**Town of Kittery
Planning Board Meeting
May 25, 2023**

ITEM 3 – 283 Route 1 Mixed Use Master Site Development Plan – Sketch Plan Review

T5037-003
May 4, 2023

**Re: Request for Site Sketch Plan Review
Proposed Mixed Use Development, 283 US Route 1, Kittery, ME**

SKETCH COLOR SITE PLAN

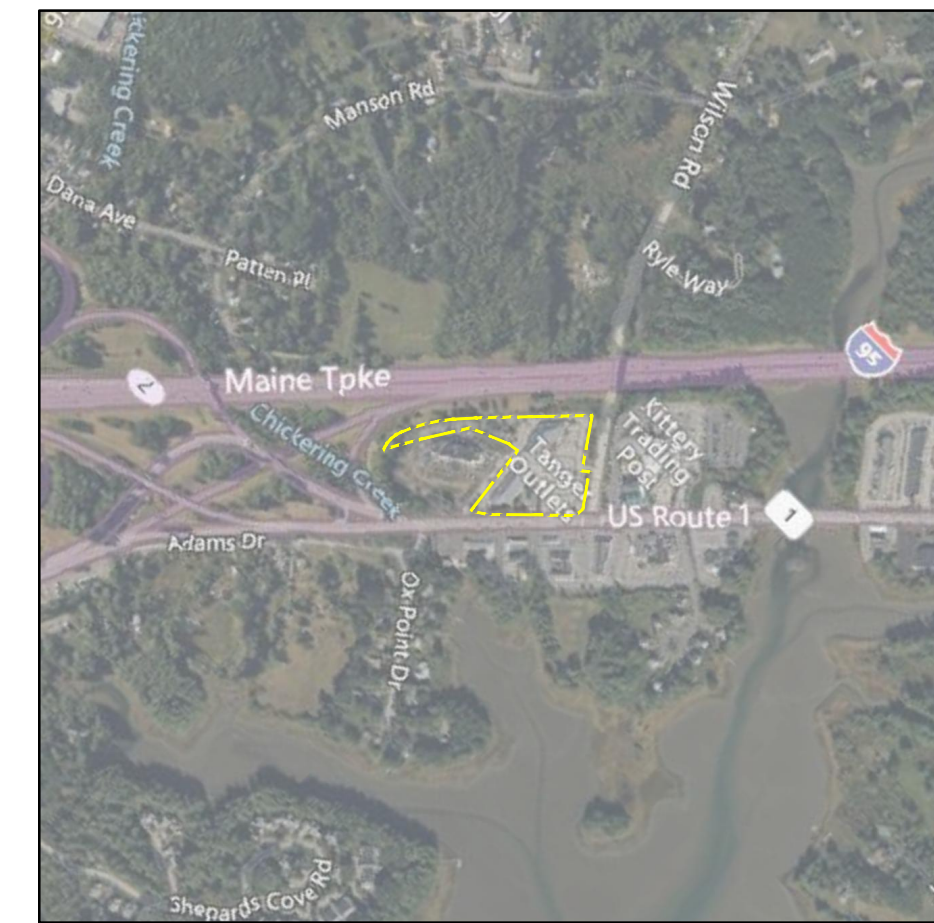
67
68 **Maximum front setbacks and relationship of buildings to public rights of way:**
69 The definition of front yard in Title 16 indicates that the *maximum* building setback of 15 feet would
70 apply to both street frontages. Should the buildings lie closer to the street/ sidewalks? Discussion with
71 Fire dept. staff pending. Placing buildings closer to sidewalks is generally deemed safer and more
72 attractive for pedestrians by visually encouraging motorists to reduce speeds, reducing crossings of
73 driveways and parking areas, shortening distances between entries and sidewalks, and creating a more
74 visually interesting walking environment. However, the applicant may present convincing rationale for
75 board consideration of alternative design(s). Guidance should be provided during this or a subsequent
76 meeting.

2.b Min street frontage	No minimum. See 16.5.14 Lots.	Yes	Frontage on two public streets. Not a flag lot or spaghetti lot.
2.c Max front setback	15 feet*	No	Prospective hotel does not comply. See discussion items.

3.d Traffic and circulation	Sidewalks and roadways required within site and to adjoining areas	Generally	Staff recommend provision of walkways connecting building entries to nearest sidewalk

4.a.2 connectivity	See 3.d.	TBD	Staff recommend pavement markings or surface variation to define walkways across driveway and parking areas
4.a.4 service areas	Fencing and screening required	TBD

- 158 F. Parking and loading: conceptual plans appear to generally comply with drive aisle and parking stall
159 standards. Parking count could be reduced.

In our April 13, 2023 Sketch Plan Review meeting we heard comments from the Planning Board which we have made an attempt to incorporate into this plan, understanding that much of this will be further developed in the remaining submissions (Site & Subdivision Review specifically). Specifically, two primary comments were discussed. The first related to evaluating greenspace around the apartment building and the second related to the front yard setback along Route 1.

While we exceed the open space requirements for the site as previously depicted, we were able to modify the footprint of the apartment building to place more of the green space toward Route 1. Around the apartment building there is an opportunity for patio space as well as

general landscaping buffers. We anticipate those areas to be developed in further detail as plans progress. We have also shown the removal of ~44 parking spaces at the southwest portion of the site which we intend to use as a dog park for both the apartment occupants and hotel guests.

The Planning Board pointed out the note in 16.4.19(E)(2)(c) above which allows the Planning Board discretion to allow a greater setback for the "regulated object, use or feature". In the event the Planning Board still interprets the regulated object, use or feature to be the building, we have made some improvements at the front of the site to supply more pedestrian friendly space. In addition to the large patio at the corner of Route 101 and US Route 1, we have added some landscape areas on the corner of Old Wilson Road and US Route 1, and a small park leading up to the hotel entrance which will extend from the top of that park to the main entry with hardscaping. The details of these areas will be developed further as plans progress, but there is space along the entire front of the site for plantings and landscape features to improve the curb appeal and pedestrian experience. Because the project is offering these public amenities, the Planning Board has discretion to allow a setback greater than 15 feet.

In the case of the 15-foot setback there is a clear benefit to public health, safety, natural environment and general welfare by having the building set back further than 15 feet from the street, especially at this location in the C-1 Zone. At this location vehicles are going faster than other sections of Route 1 given they are typically coming off of, or going onto, I-95. Moving the building 15 feet from the road is not likely to cause these vehicles to slow down at this location, it will simply make for a more dangerous environment. A combination of things would happen if the building were placed this close to the road.
